SNARL Classroom/Lecture Hall
FM140248L/981800
Addendum No. 2

April 10, 2014

ADDENDUM NO. 2

REFERENCE SHEET M2.2

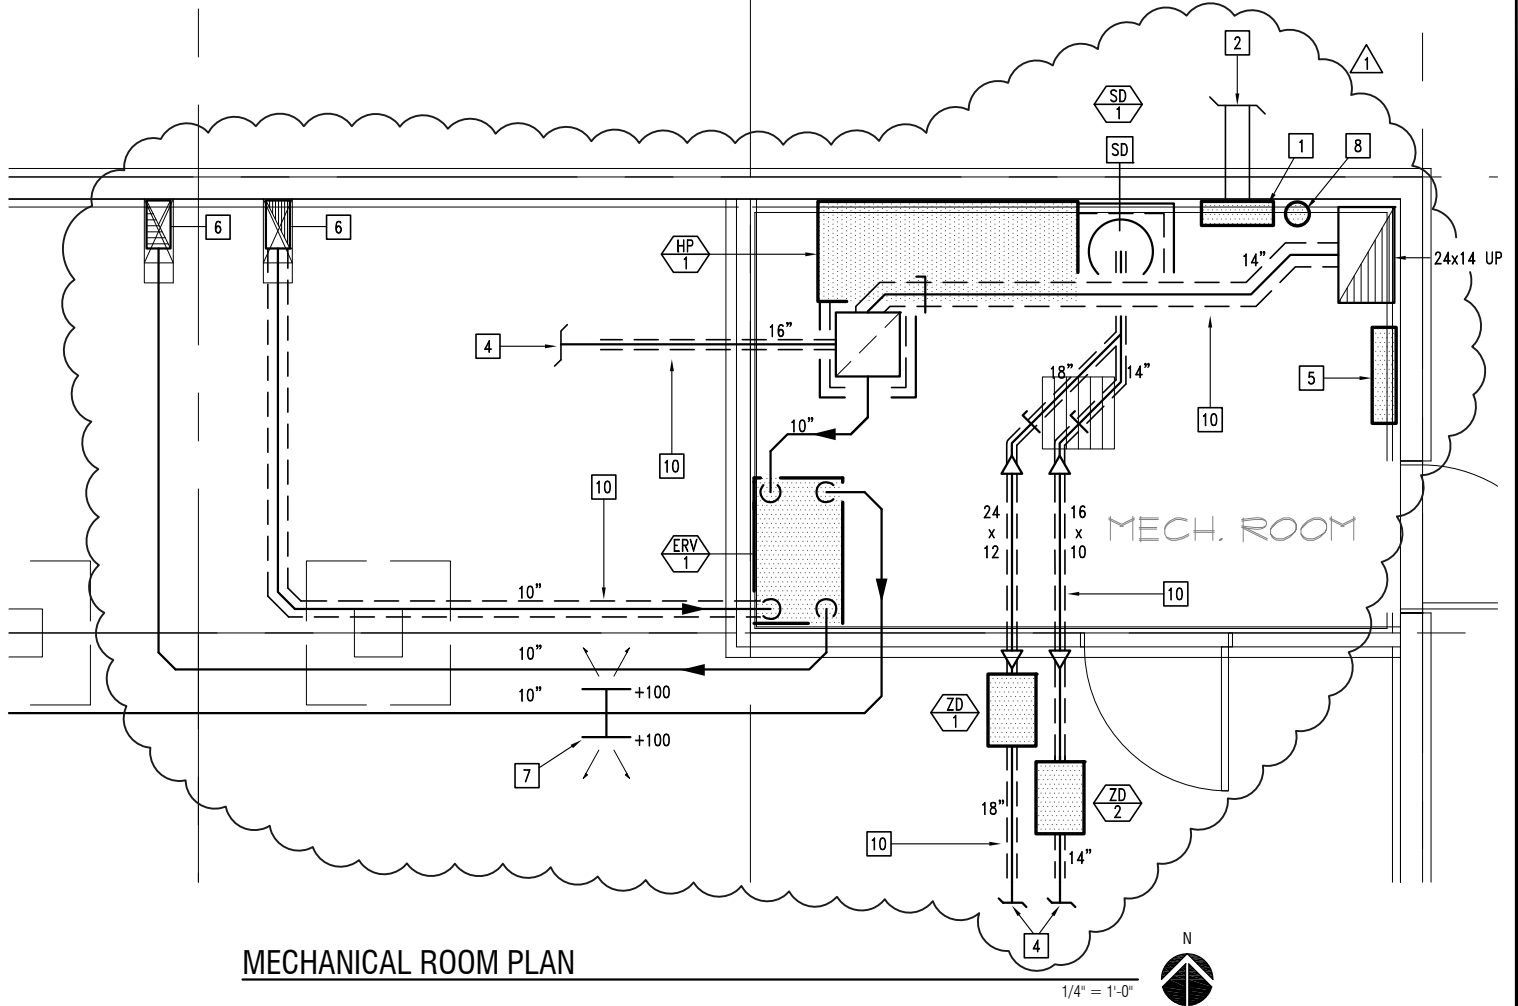
- 3-5 MODIFY Sheet M1.1, SYMBOLS, GENERAL NOTES – PRODUCTS, as described in the attached Exhibit B (See Page 1).
- 3-6 MODIFY Sheet M2.2, MECHANICAL ROOM PLAN, as described in the attached Exhibit B (See Page 2).

- 1 GEO-FLOW FLOW CENTER.
- 2 CONDENSER WATER PIPING TO GEOTHERMAL MANIFOLDS. HDPE PIPING. MAKE CONNECTION 5 FEET OUTSIDE OF BUILDING. SEE ARCH.
- 3 GEOTHERMAL BORE FIELD N.I.C.
- 4 DUCTS INTO CRAWL SPACE. SEE M2.1 FOR CONTINUATION.
- 5 GEOTHERMAL SYSTEM CONTROLS.
- 6 12x6 ERV INTAKE/EXHAUST DUCTS UP SHAFT.
- 7 PROVIDE ERV OUTLET REGISTERS IN CRAWLSPACE, SPACED EVENLY FOR CRAWLSPACE VENTILATION.
- 8 GEO-PRIME TANK.
- 9 OUTLET AT WEST END OF CRAWLSPACE.
- 10 1 INCH DUCT LINER PER SPECIFICATIONS, FIRST 10 FEET OF SUPPLY AND RETURN PLENUMS AND DUCTWORK AS SHOWN. THE REMAINDER OF UNDER-FLOOR DUCTWORK SHALL BE UN-INSULATED.
